U.S. NUCLEAR REGULATORY COMMISSION

Report No. 50-255/90020(DRS)

Facility Name: Palisades Nuclear Generating Plant

Inspection Summary

Fig. 1

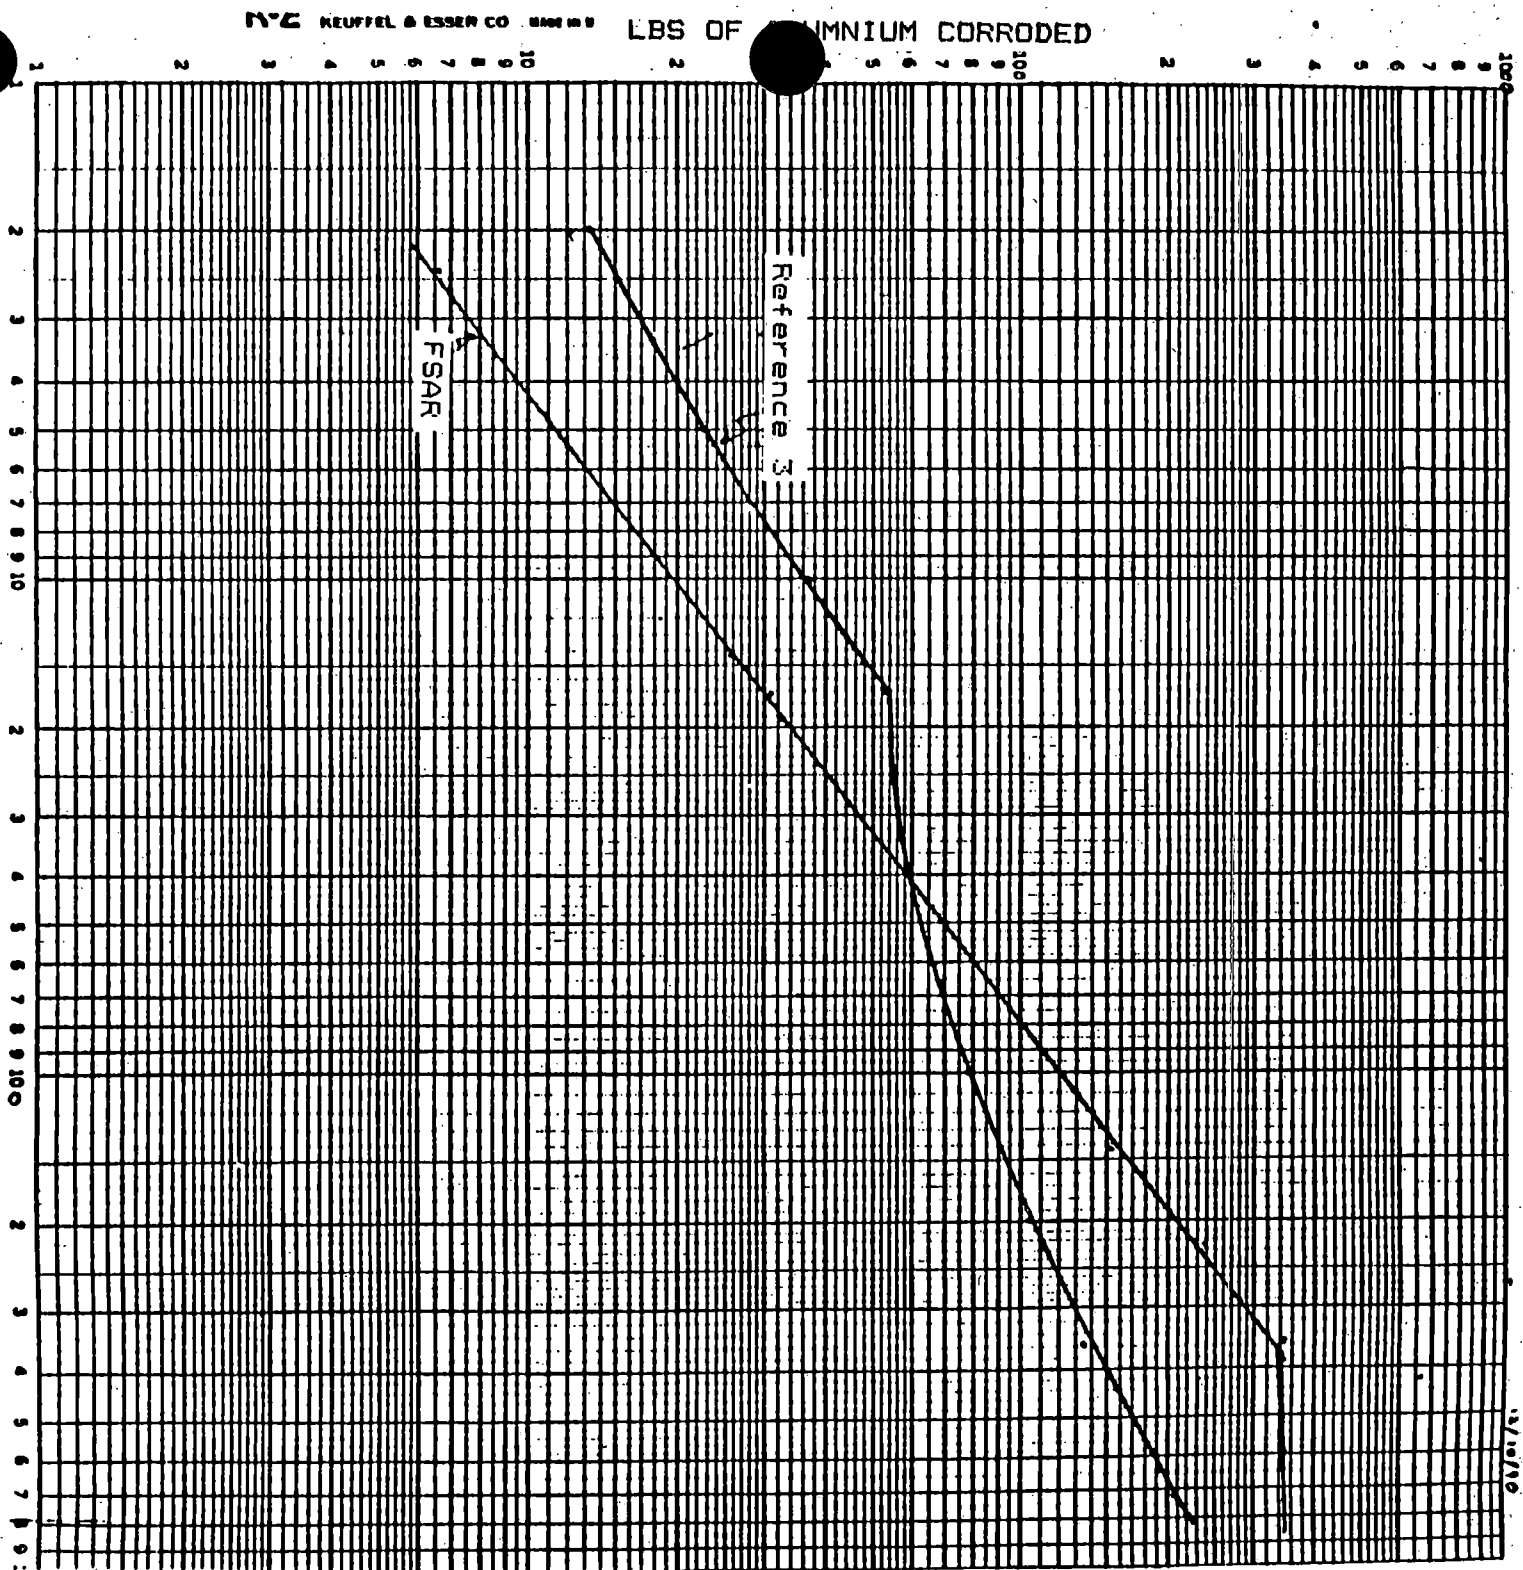
The staff compared the aluminum corrosion rates between the FSAR and Reference 3. Further, using the temperature values as a function of time, we calculated the amount of aluminum corroded as a function of time. The results shown in Figure 1 indicate that for the first 40 hours after an accident, the FSAR methodology underpredicts the amounts of aluminum corroded, but after that time the FSAR results are more conservative relative to the results based on the time dependent corrosion rates of Reference 3.

Corrosion of Zinc on Galvanized Steel in Post-Accident Environment

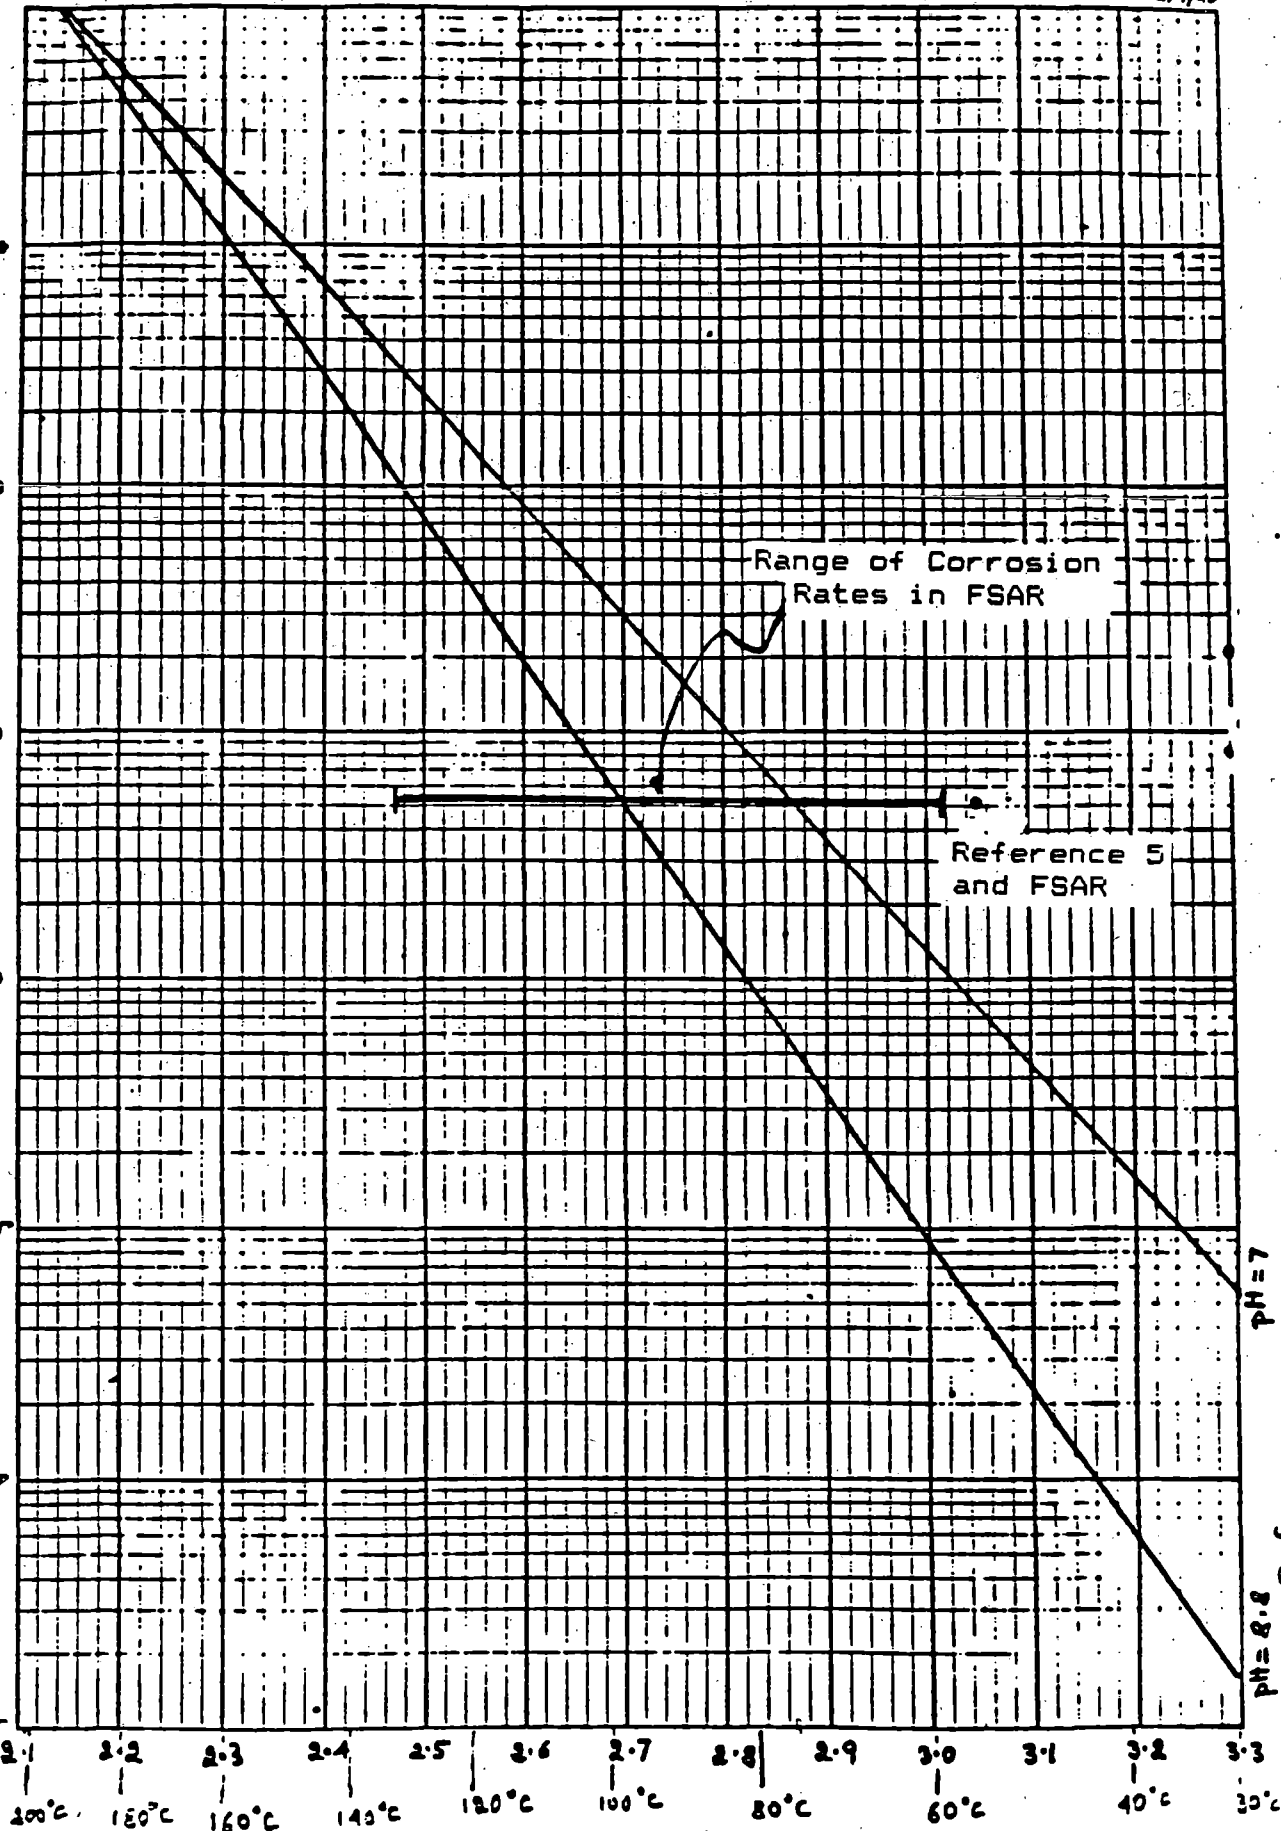
However, after Sandia's analysis was completed, the staff discovered an additional source of information (Figure 2) on corrosion of zinc on galvanized surfaces from an experimental program performed at Sandia National Laboratories (Reference 4). The staff obtained and evaluated the information and made an engineering judgment that the effect is insignificant to its conclusion. A reanalysis is not necessary since the time dependent hydrogen generation from zinc, as shown in Reference 2, is a small fraction of the total hydrogen generation.

FIG. 3

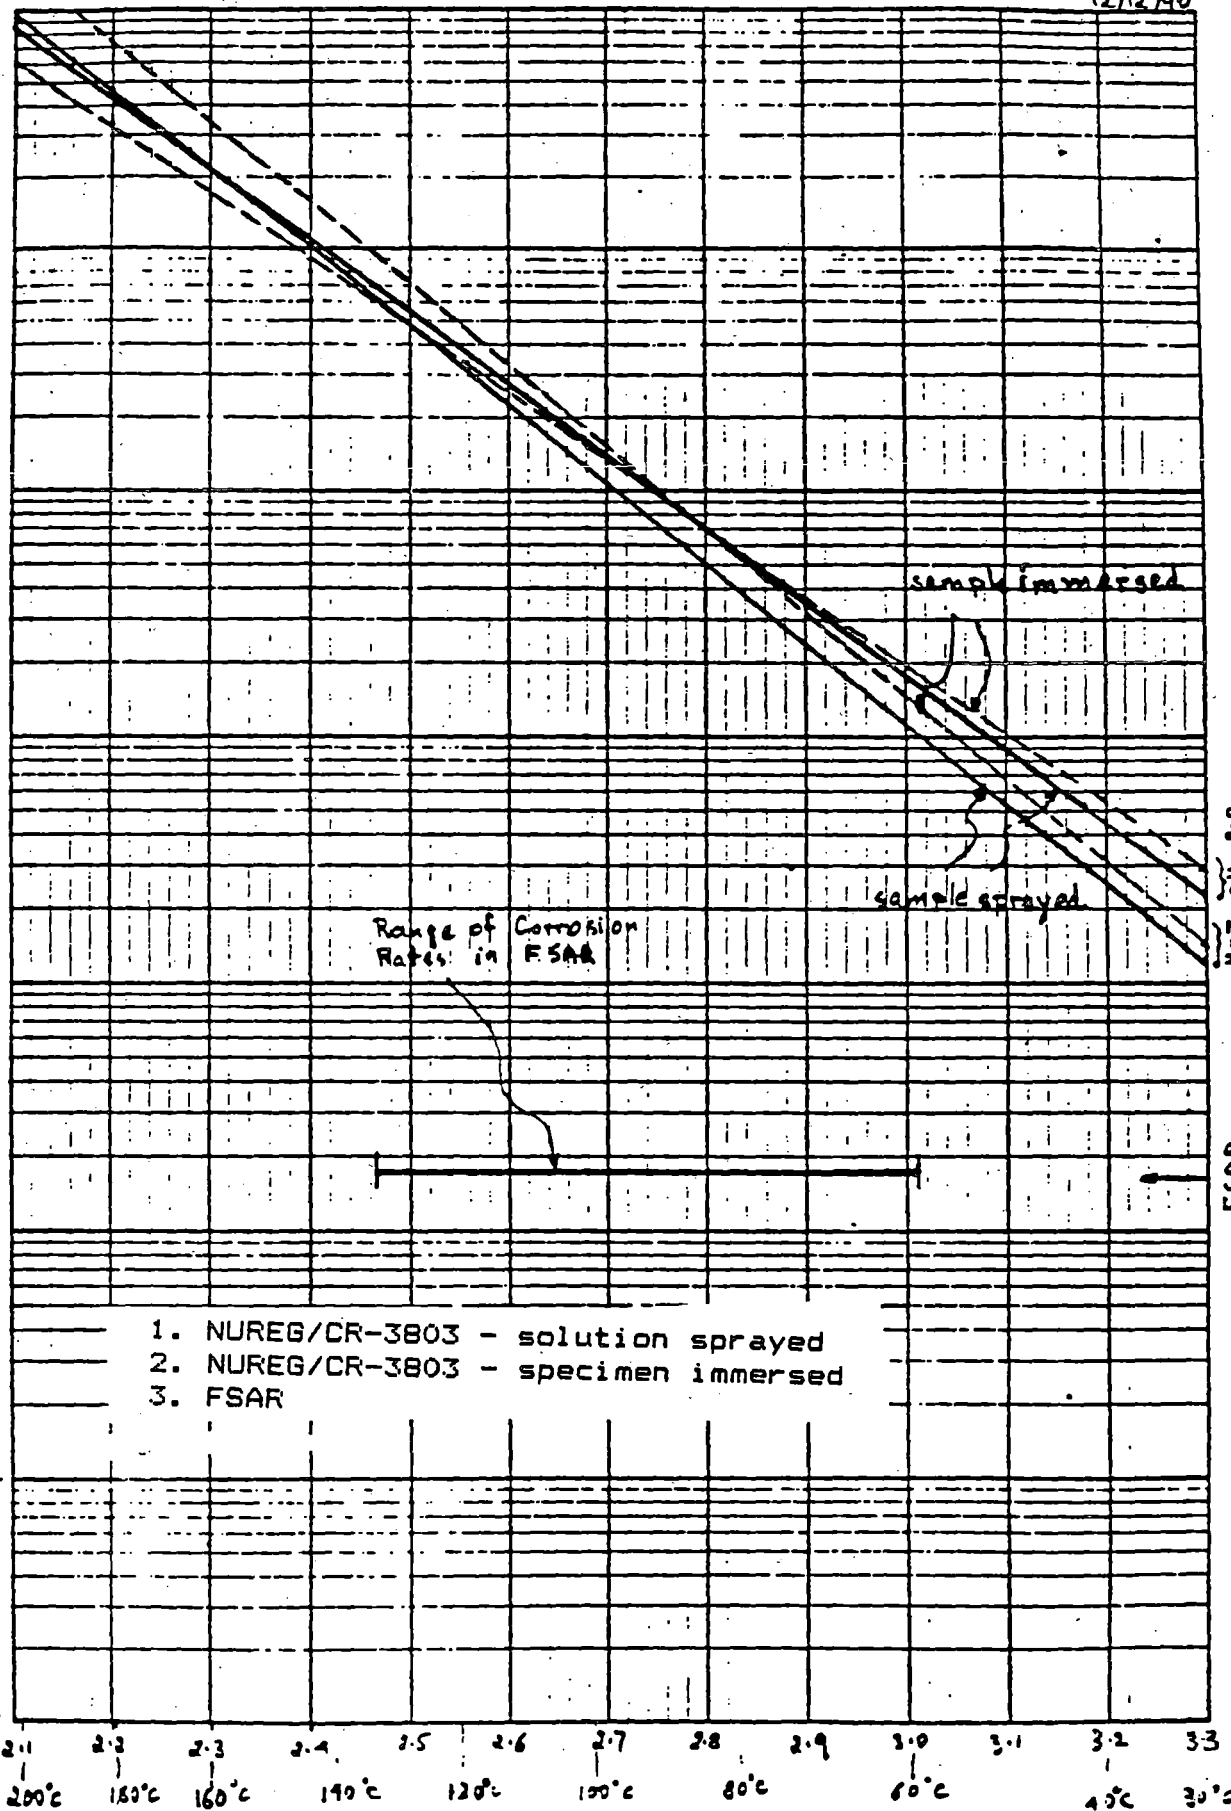
The information on corrosion of zinc paints comes from a test program performed at Sandia National Laboratories (Reference 7). The corrosion rates are a function of temperature and pH values. As shown in Figure 3, the corrosion rates from Reference 7 are significantly higher than the constant corrosion rate used in the FSAR, which is test data obtained by the licensee. The large difference is probably from the difference in test conditions; the tests reported in Reference 7 were run at conditions
